Proposal from Japan to review the requirements for forward field of vision
in Regulation No.125

Figure 1. Basis for the Requirement Concerning the Field of Vision under the Japan's Provisions

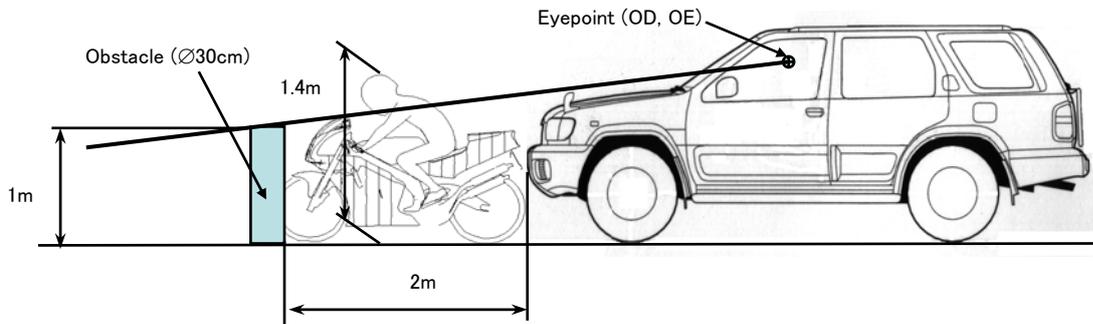
Japan's regulations specify the size of and distance to an obstruction as follows on the assumption that a two-wheeled vehicle is being driven immediately in front of the vehicle (figure 1). This is based on the idea that a two-wheeled vehicle, the smallest possible vehicle that may exist in the driving direction of a running vehicle, should be visible in the direct forward field of vision of drivers of passenger cars and motor trucks with a gross vehicle weight of 3.5 tons or below.

Figure 2. Image of the Requirement to be Added to Regulation No.125

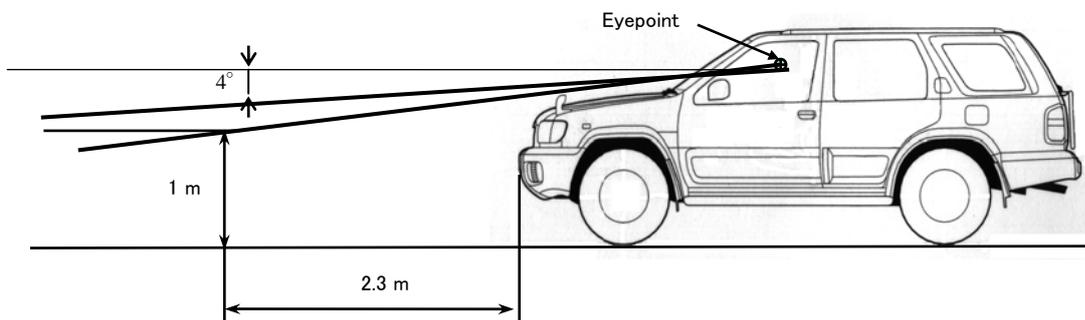
In order to add this requirement to the current Regulation No.125, the wording of the additional requirement is being examined as follows (after examination, requirement proposals will be submitted as a working document at the next session. See Figure 2).

In paragraph 5.1.3, "...one being perpendicular to the plane X-Z and declining forward 4 degrees below the horizontal..." should be amended as "...one being perpendicular to the plane X-Z and declining forward 4 degrees below the horizontal (or if the angle below the horizontal between the plane being perpendicular to the plane X-Z, and passing through the point V2 and the straight line perpendicular to the plane X-Z at a distance of 2.3 m from the front of the vehicle and at a height of 1 m above the ground, and the horizontal exceeds 4 degrees, this plane (see Figure (XX), in Appendix of Annex 4),"
